WCAP-12391

WESTINGHOUSE BOILING WATER REACTOR  
EMERGENCY CORE COOLING SYSTEM EVALUATION MODEL:  
CODE DESCRIPTION AND QUALIFICATION

SUBJECT: ACCEPTANCE FOR REFERENCING OF LICENSING TOPICAL  
REPORTS WCAP-11284 AND WCAP-11427 REGARDING THE  
WESTINGHOUSE BOILING WATER REACTOR EMERGENCY  
CORE COOLING SYSTEM EVALUATION MODEL

Figure 12-8 TLTA 6425/2 Rod Temperature Response

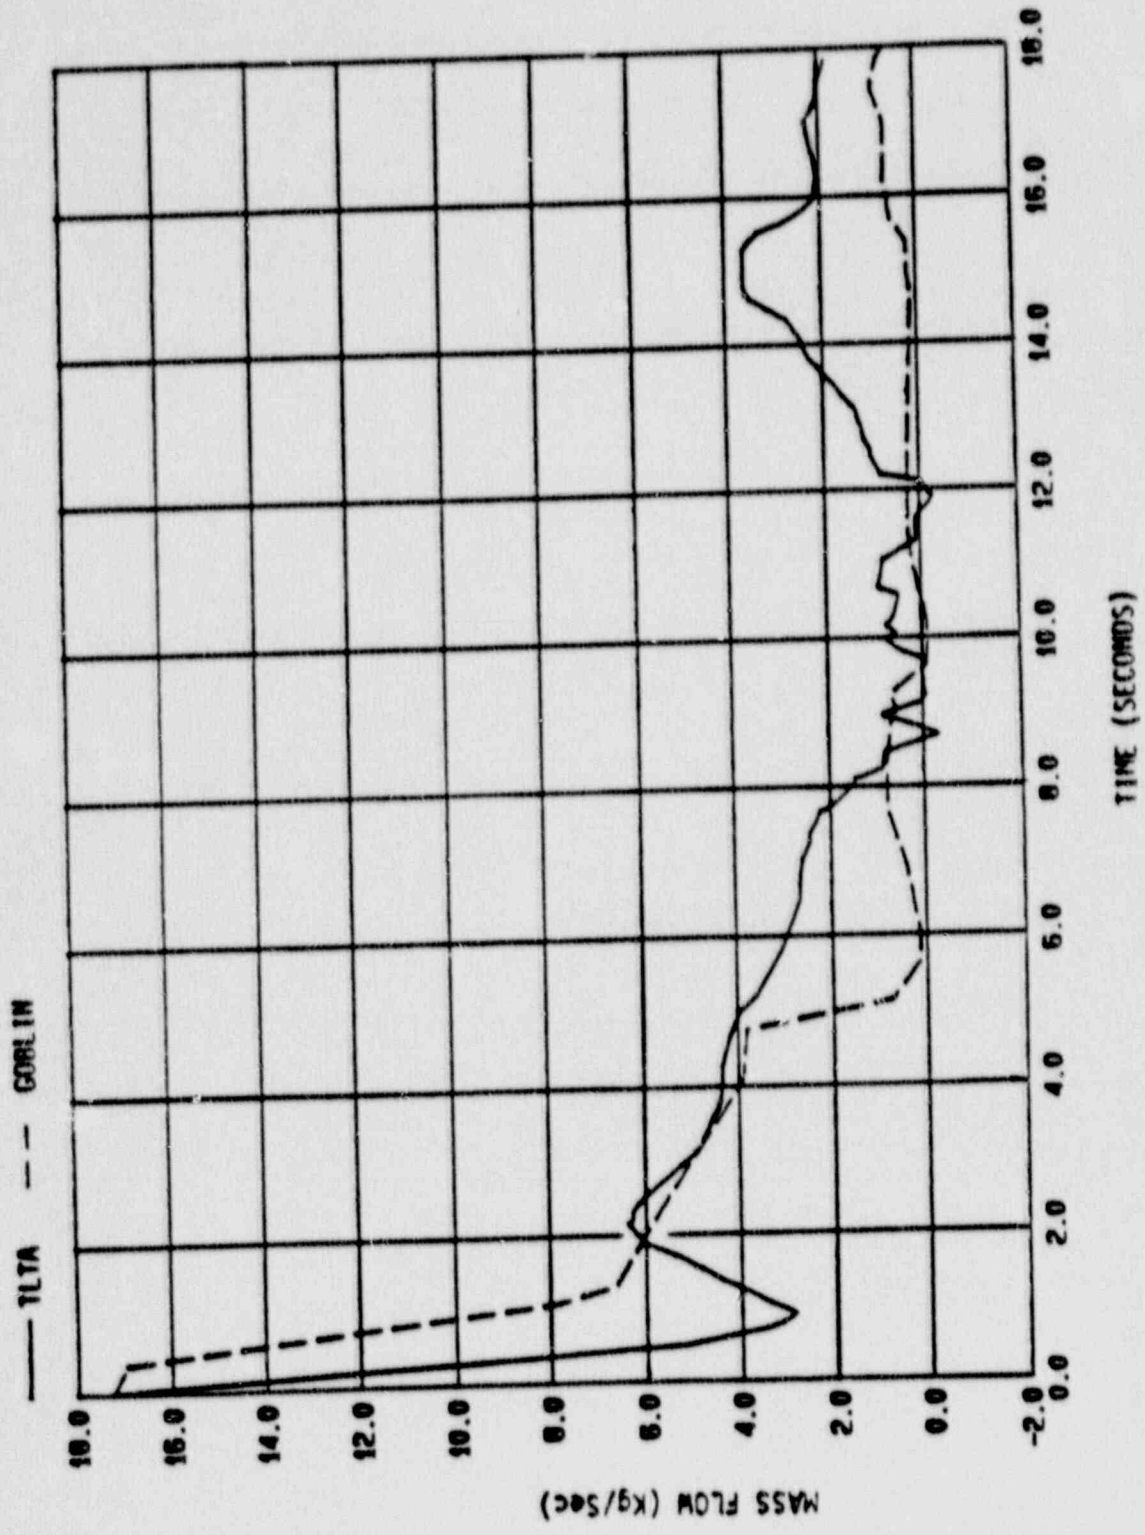
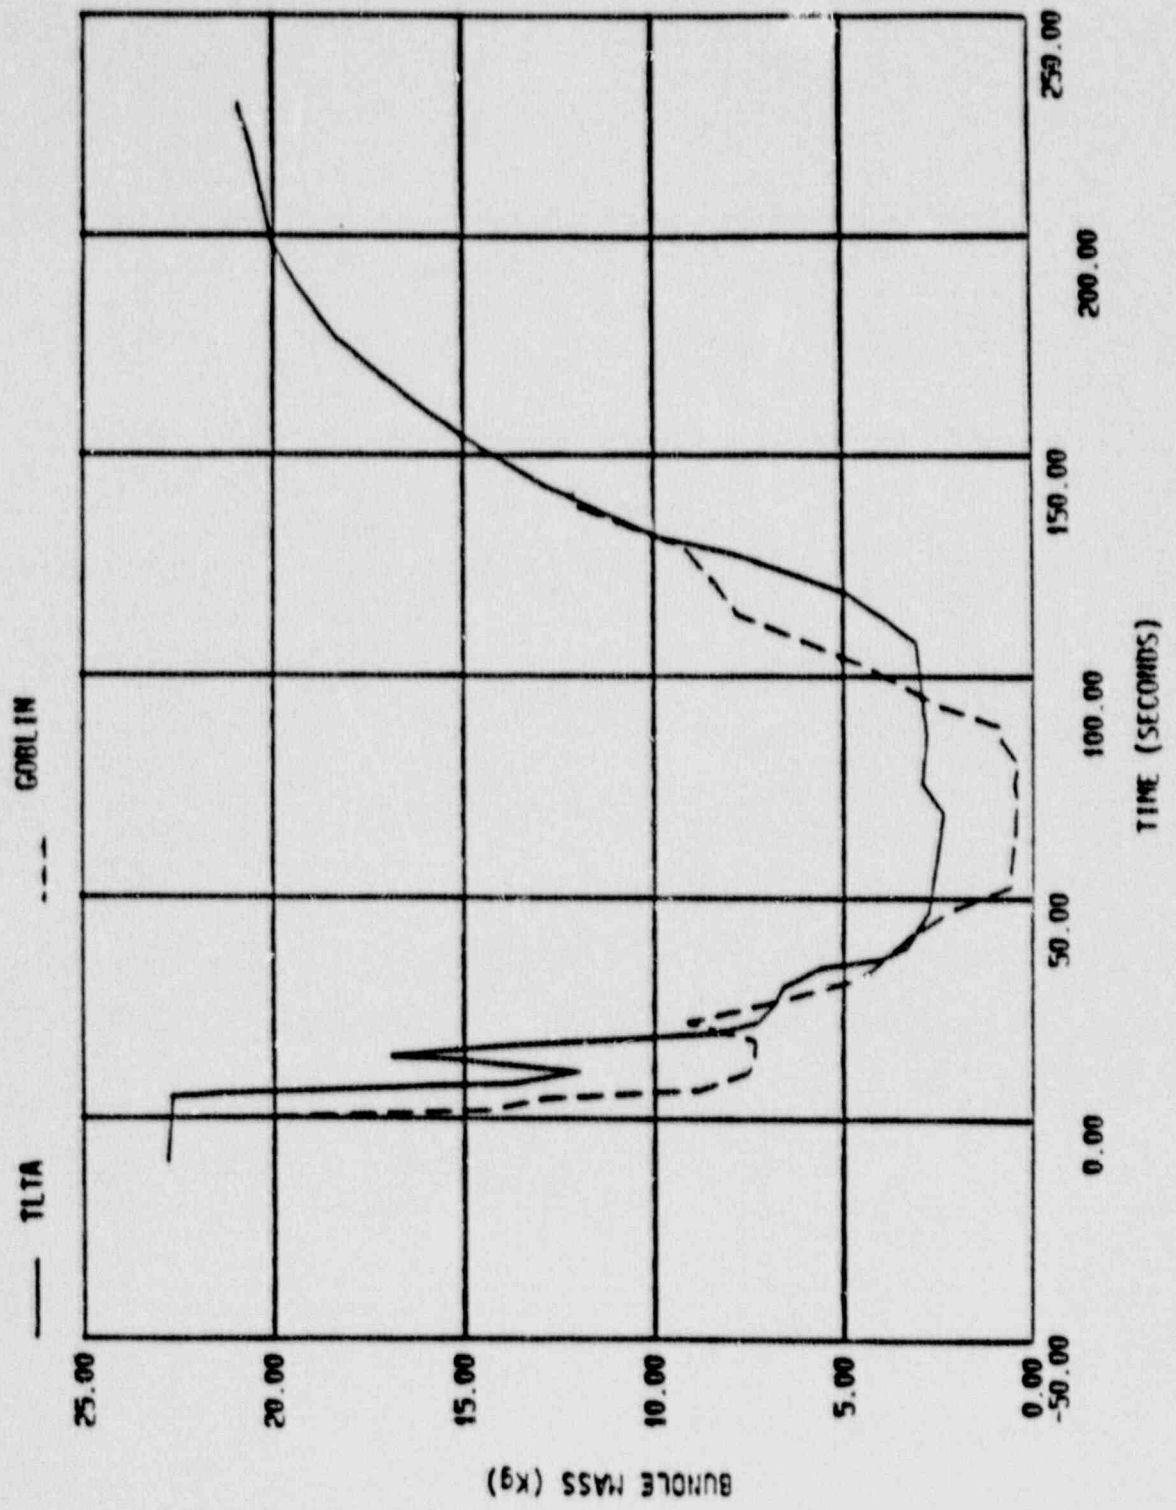
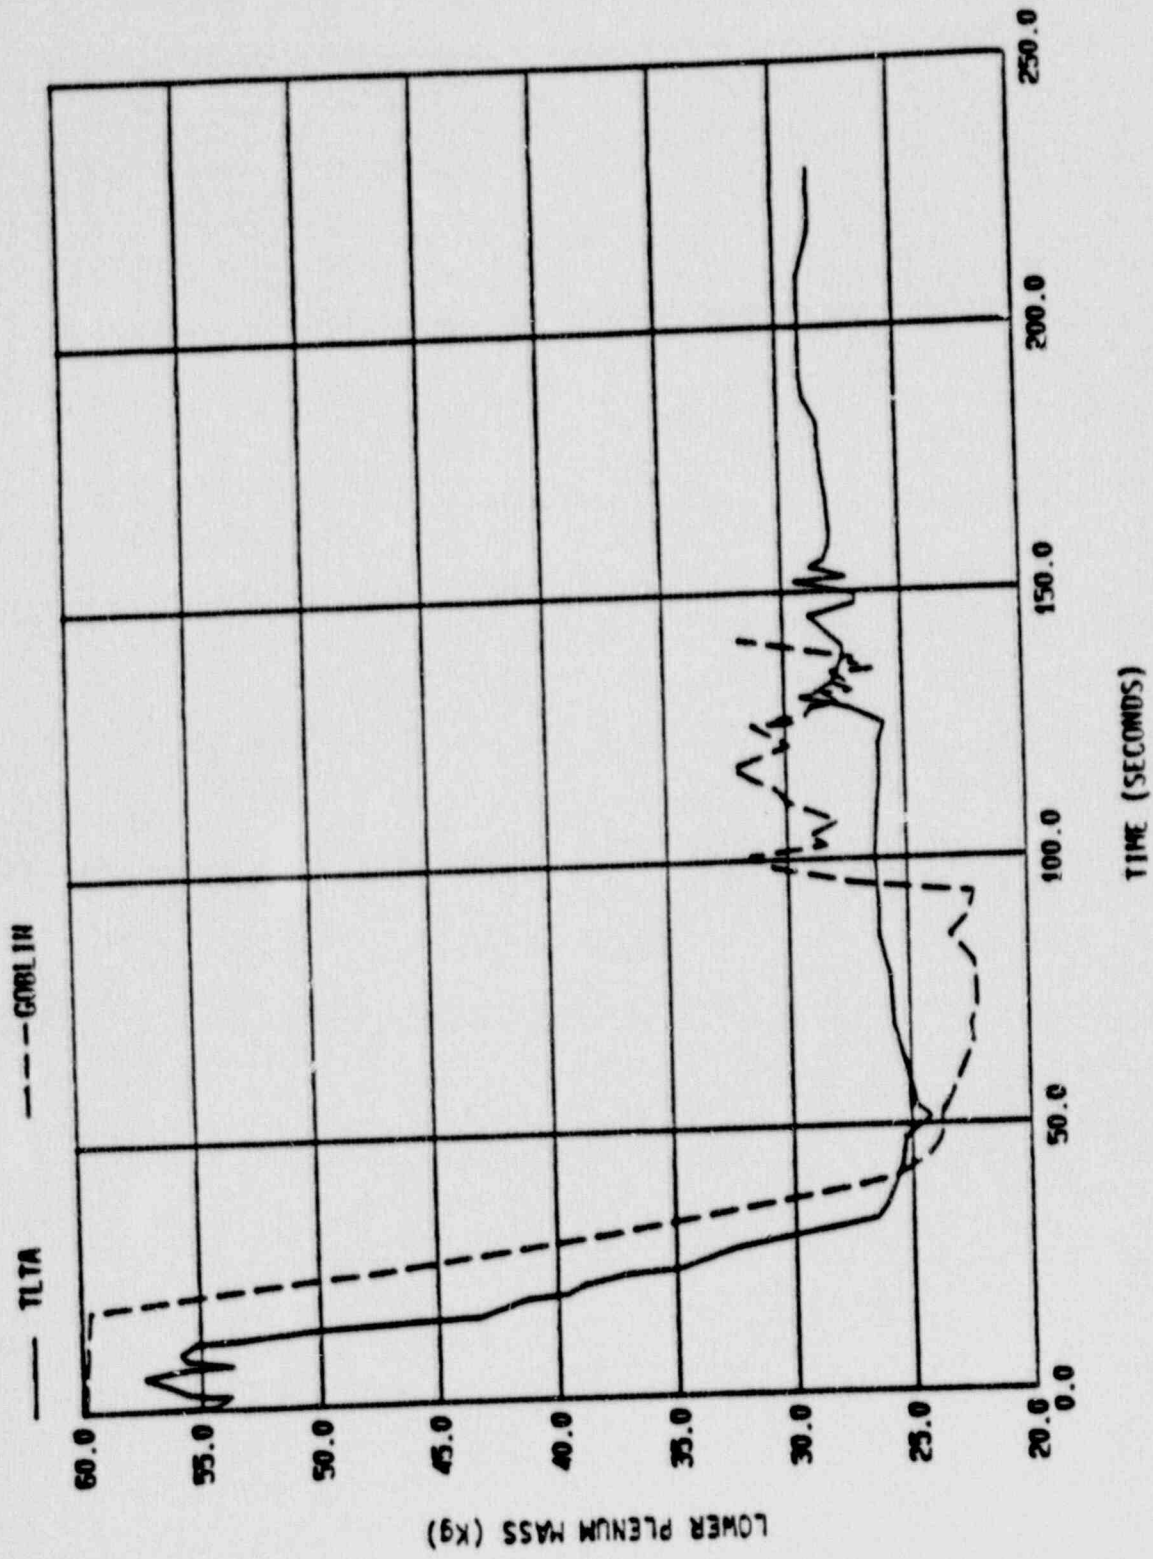
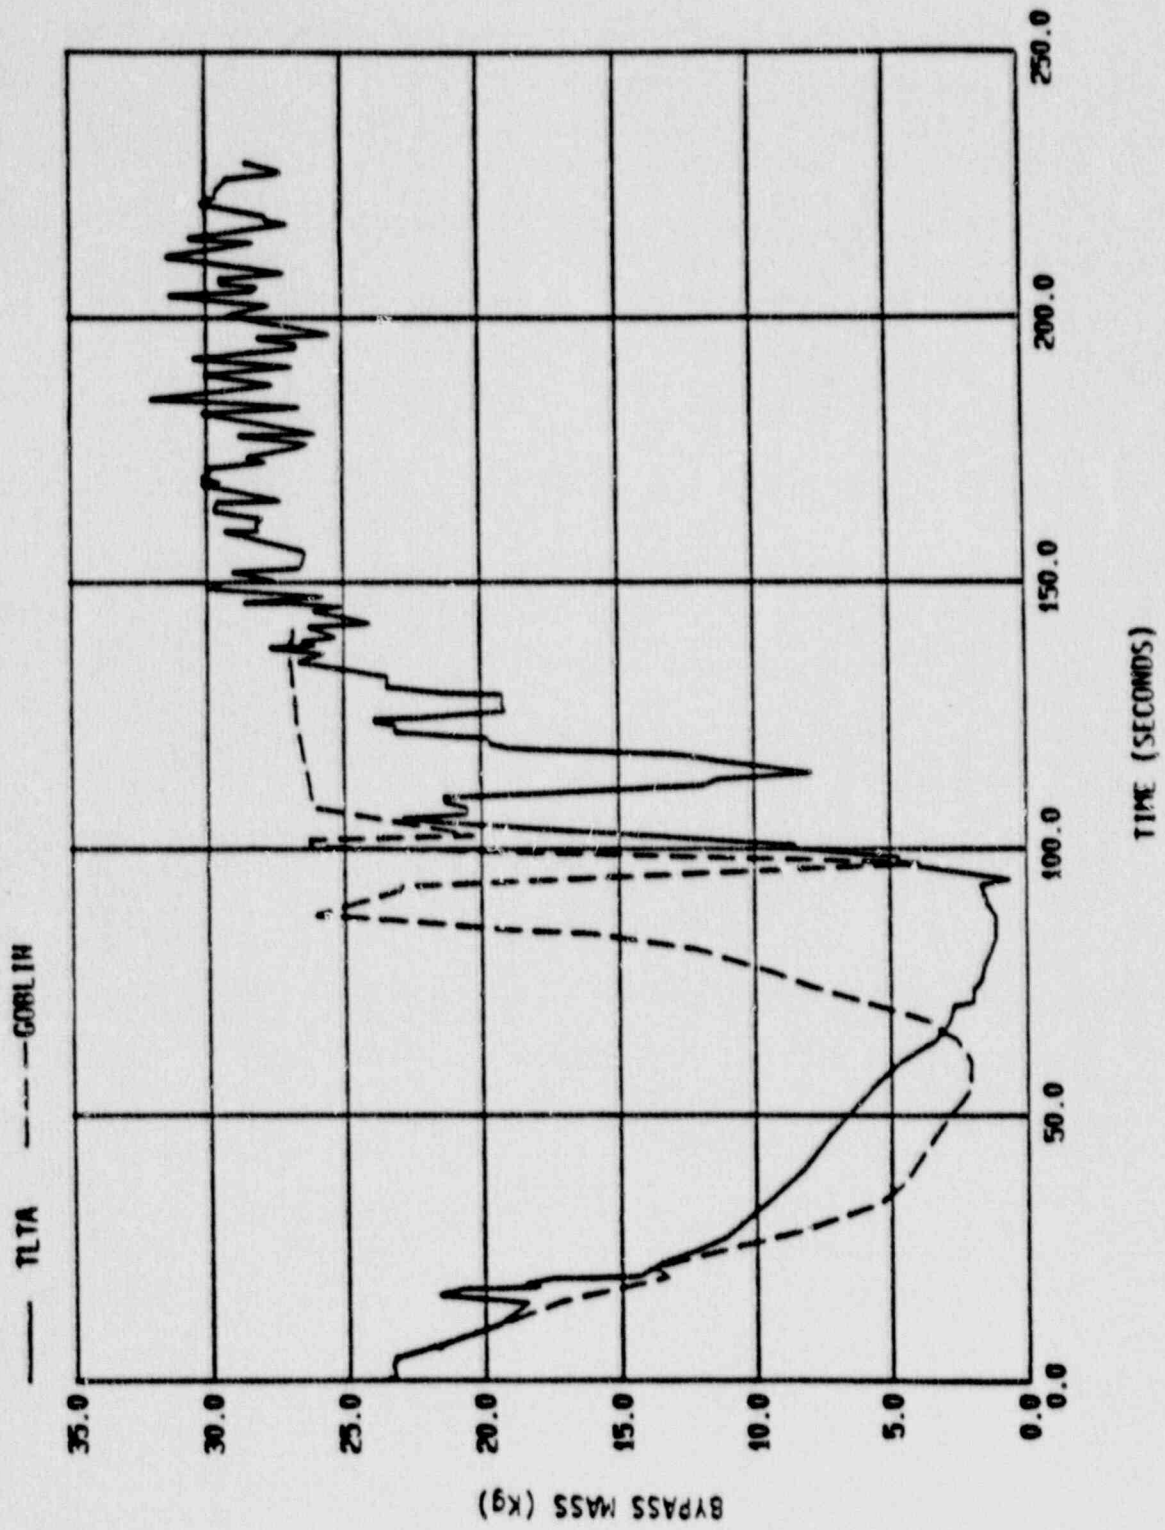
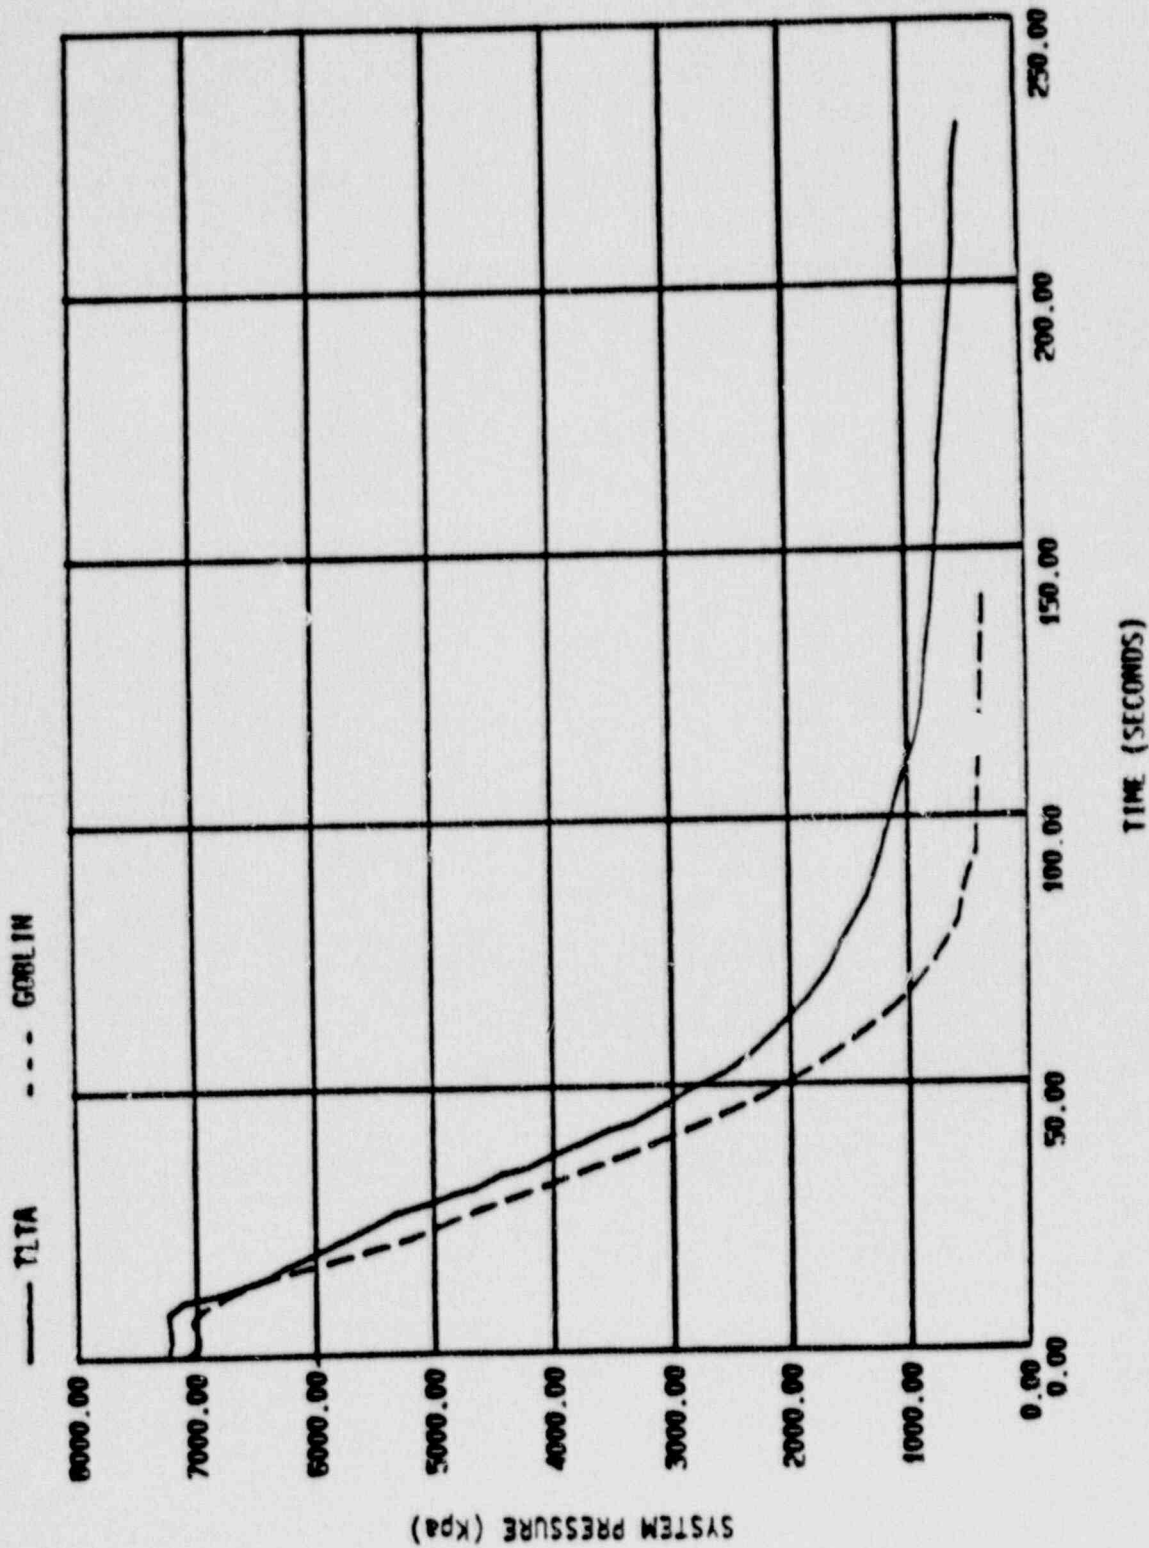
Pages 6-94, 6-98 and Sec. 6.2.3, Ref. 1. The rod temperature results are missing in the Westinghouse analysis of TLTA test 6425. In effect, these analyses have been presented in the form of separate-effects tests to demonstrate the correct response of the fuel rods. Based on Figs. 6-50 and 6-54, it appears that the code has no conservative margin in terms of PCT. In fact, the code predicts a cooldown from 40 s to 70 s in Fig. 6-50, and the data indicate a heatup. The observed differences need to be explained. Fig. 6-54 does not indicate which test rod the computational rod was simulating or what the differences are between the curves for the measured data. The rod locations for the measurement curves and which rod(s) were being simulated with the computational rod need to be identified.

The TLTA integral qualification simulation results of case 6425 run presented in Ref. 1 are repeated here. Table 12-1 shows the initial conditions for the test and simulation. Figures 12-1 through 12-7 are replotted comparisons of the transient hydraulic response. These figures supersede Figures 6-33 through 6-39 of Ref. 1. Figure 12-8 shows the corresponding rod temperature response.
